# HURRICANE CITY UTAH

### Hurricane Planning Commission Meeting Agenda

March 10, 2022

SHEET TITLE:  
**PRELIMINARY  
PLAT  
WEST PHASE**

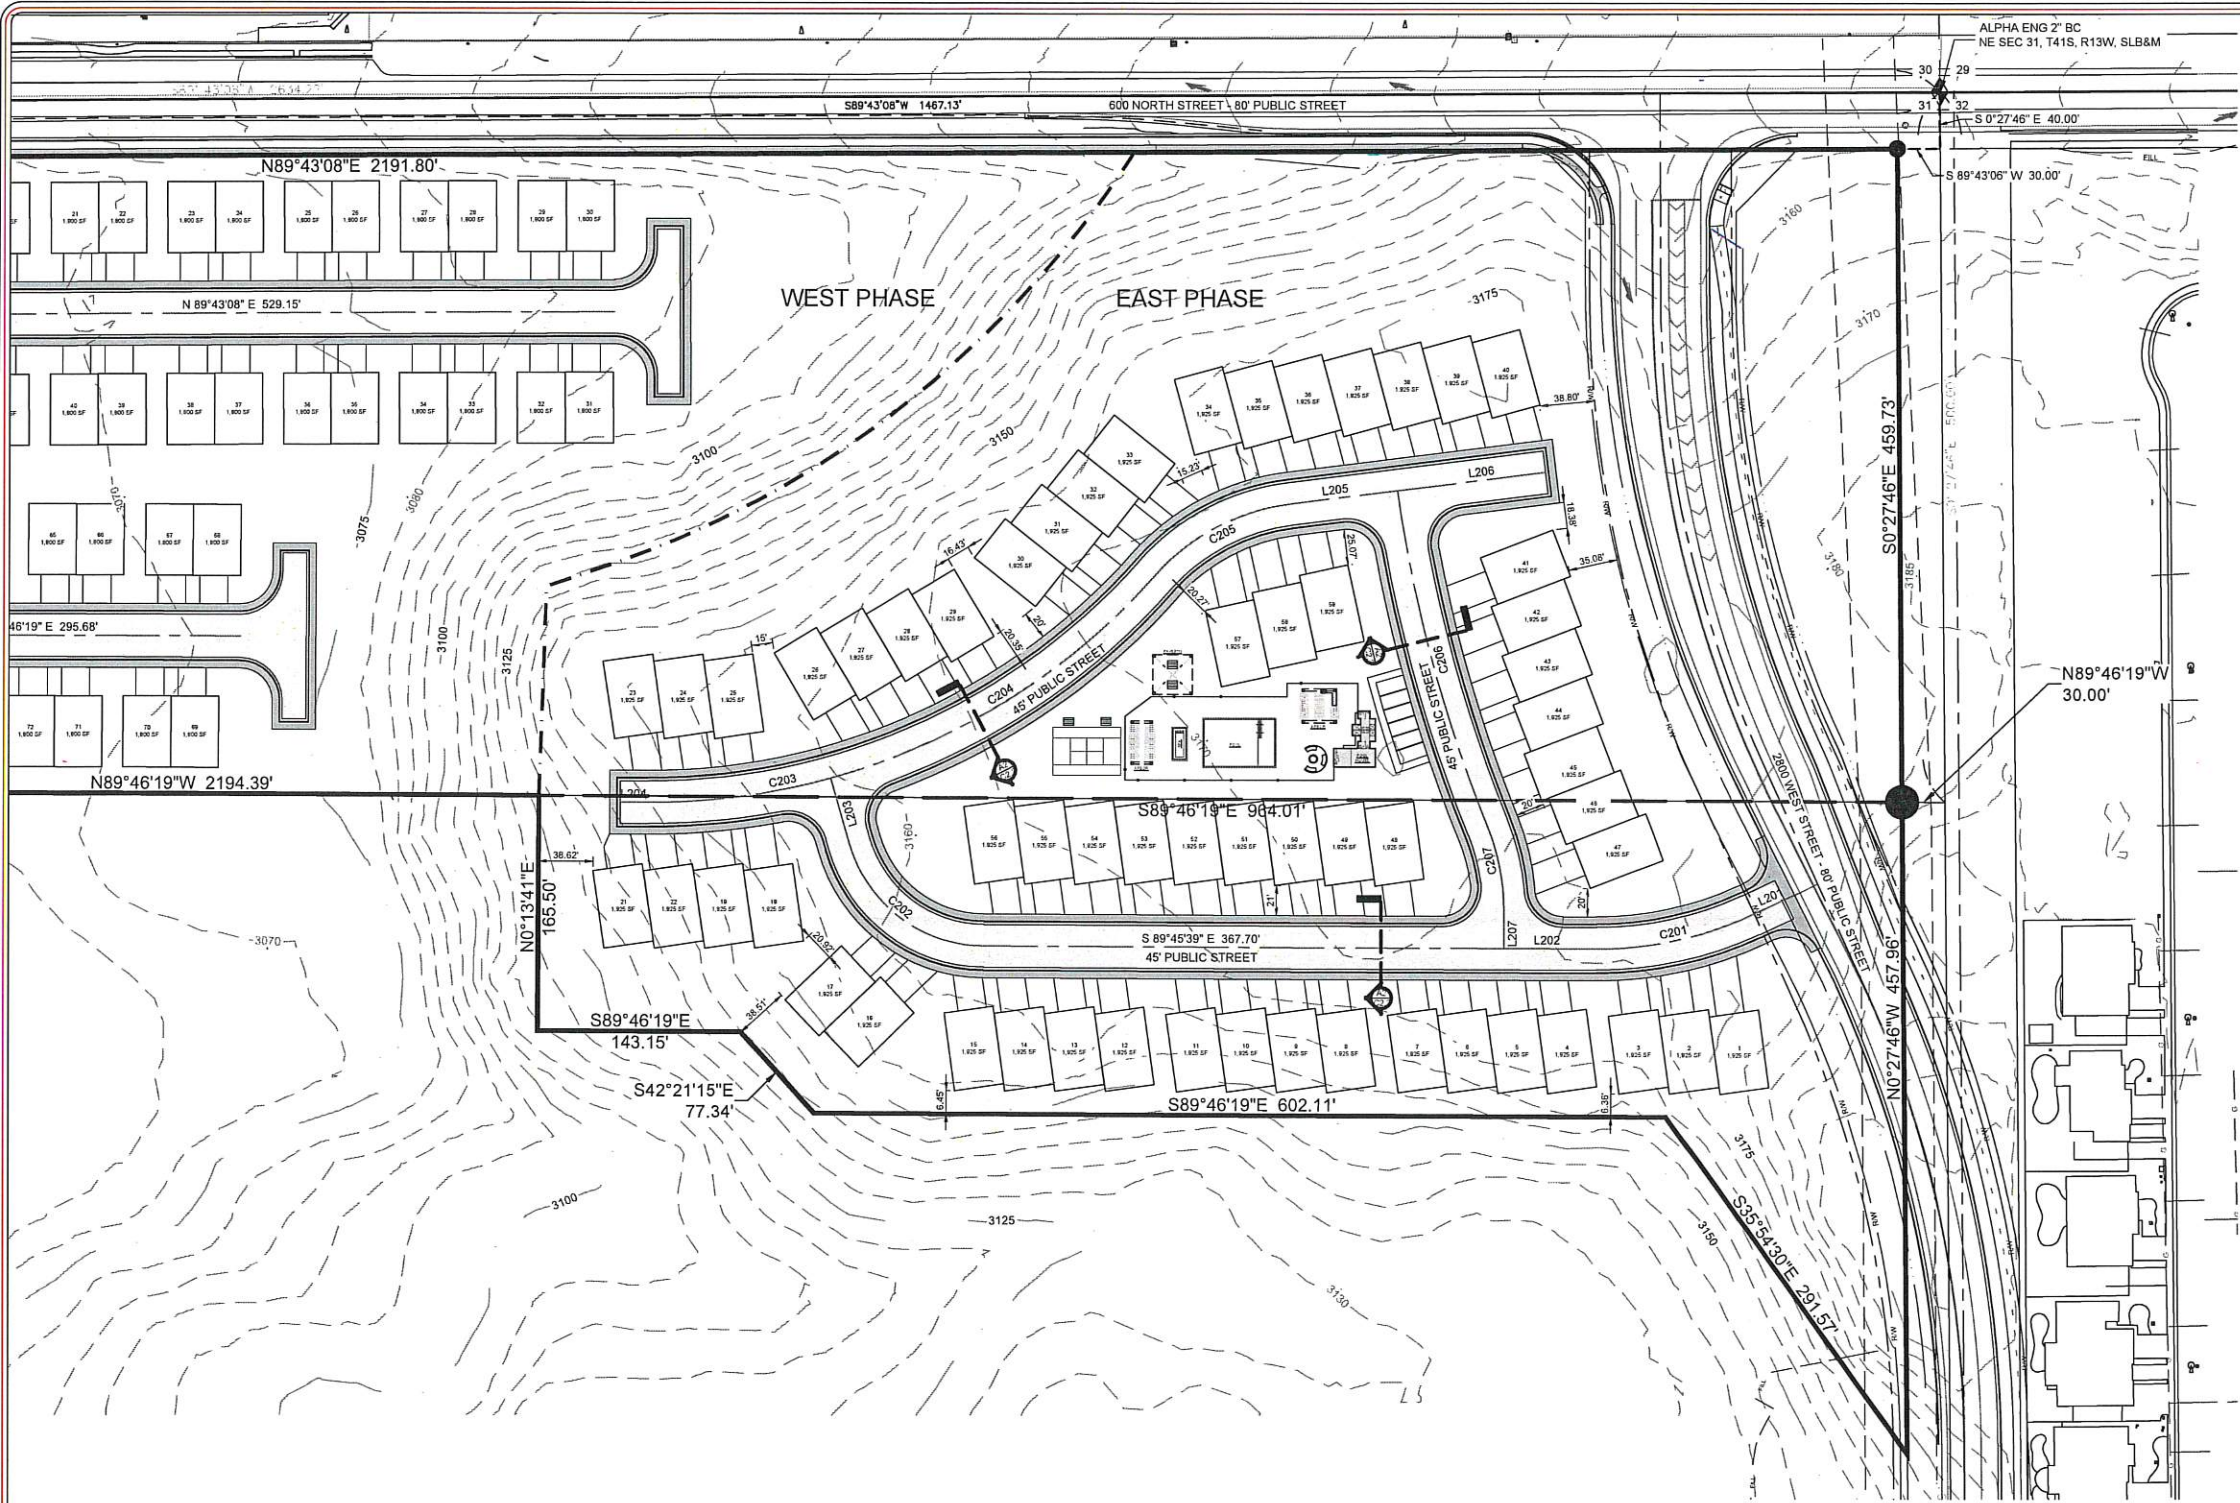
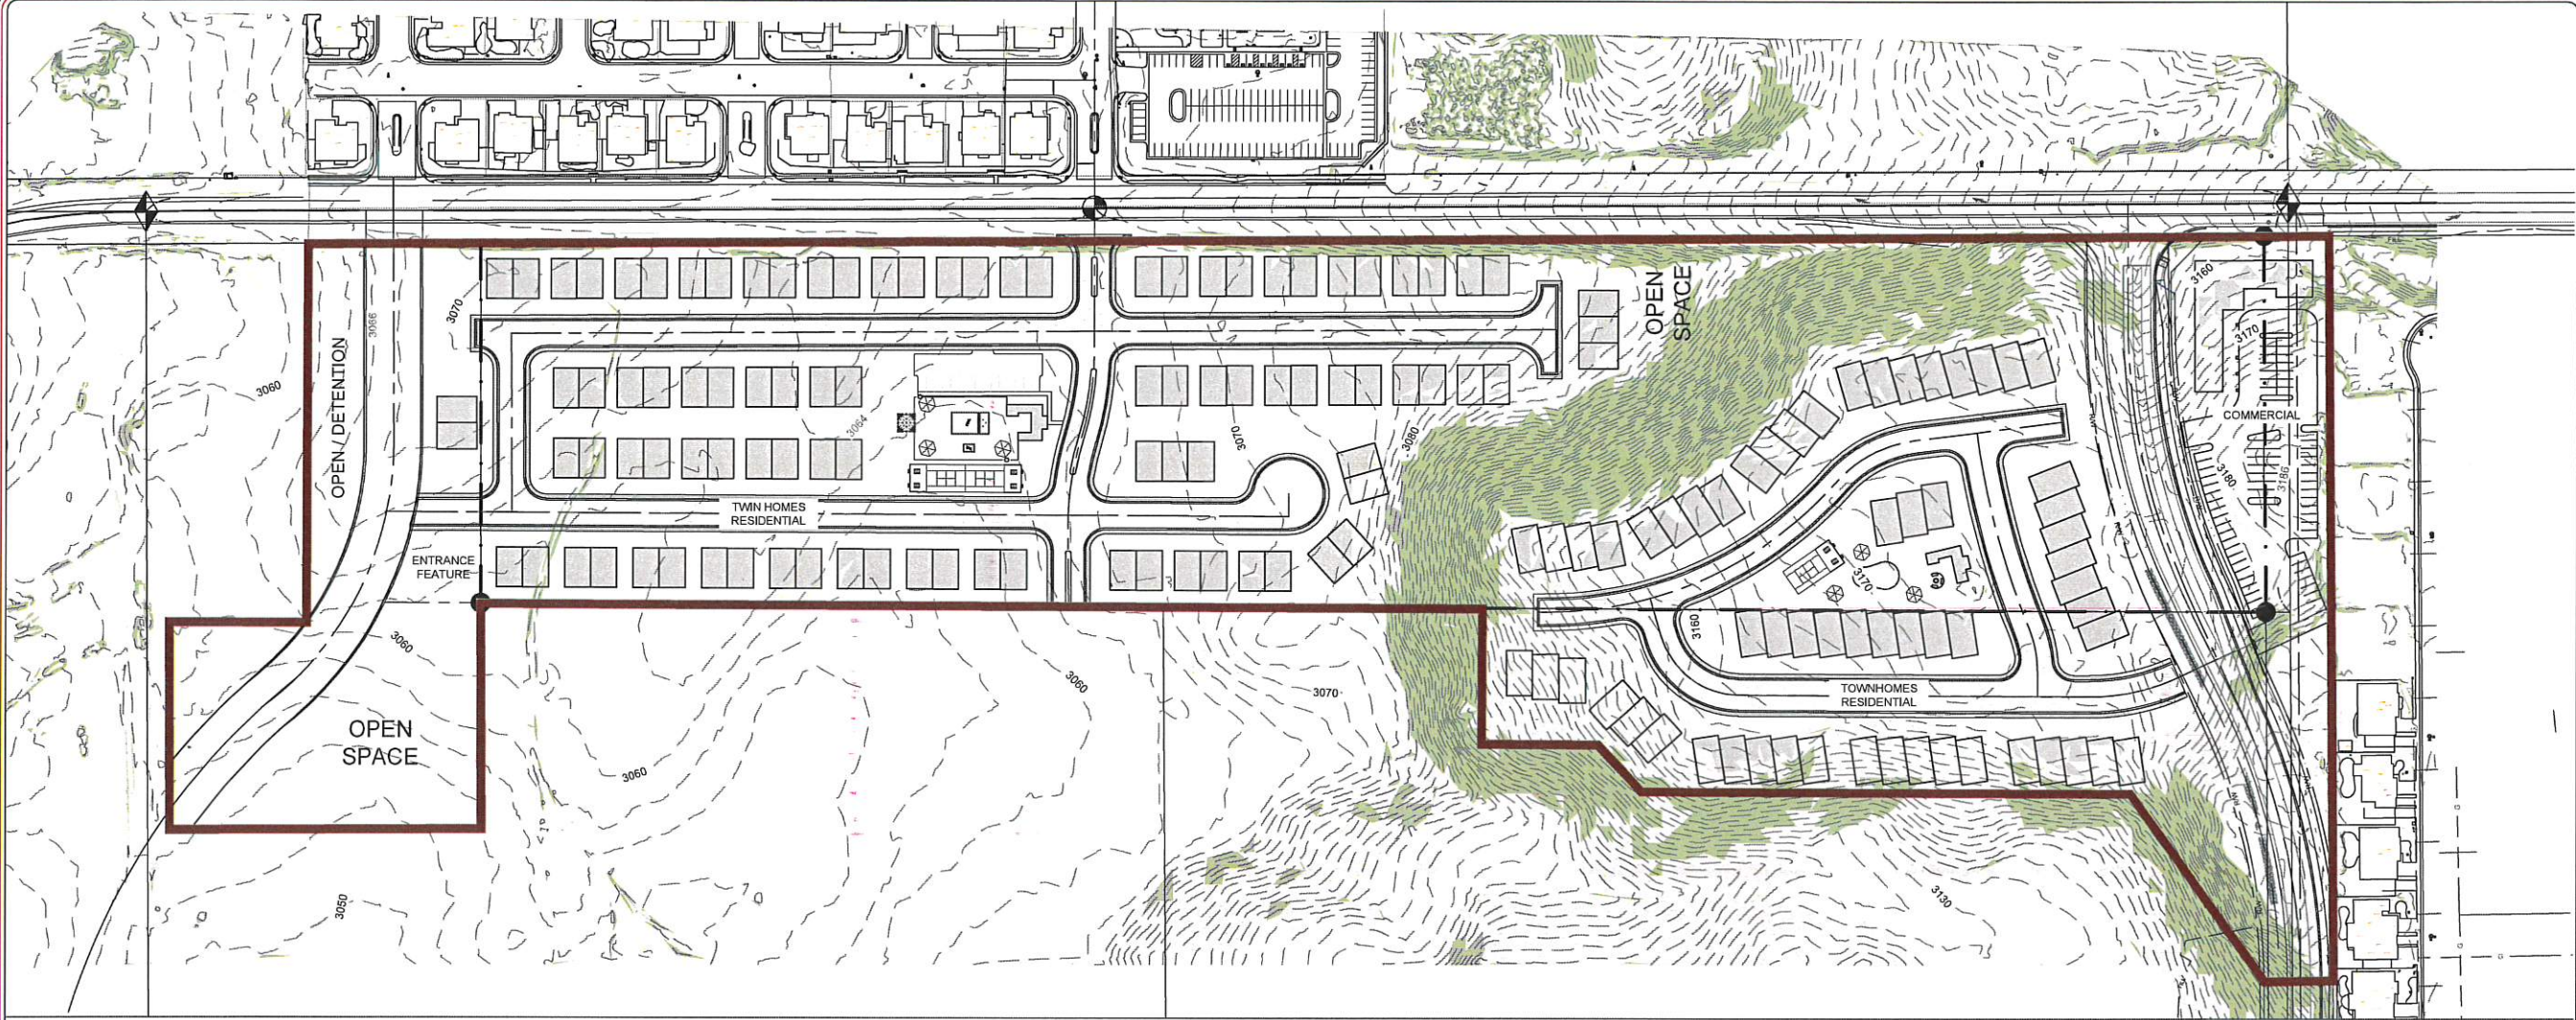
1. **Power:** East side of 2800 W is planned to have a major transmission line, this will likely not impact their layout. Power improvements needed.
2. **Sewer:** Sewer is in a portion of 600 N, needs to coordinate with Ash Creek.
3. **Streets:** No comments
4. **Water:** Two different pressure zones. 2800 W will need to be built down to access. Water loop required on eastern phase. 12" ductile iron line needed on 3000 W
5. **Engineer:** Traffic study needed. Drainage study and geotech study needed. Need to see street cross sections
6. **Fire:** Upper section needs to be sprinkled. Lower section needs second access functional
7. **Cable/Phone:** Good
8. **Gas:** Good
9. **Water Conservancy District:** No comments

9. The applicant will need to provide a utility easement from the north road to 2800 W for proper utility looping. A pedestrian access should be added to provide better connectivity to 2800 W.

**Recommendation:** Staff recommends the Planning Commission review this application based on standards with Hurricane City Code. Staff would recommend approval of this preliminary plat subject to staff and JUC comments
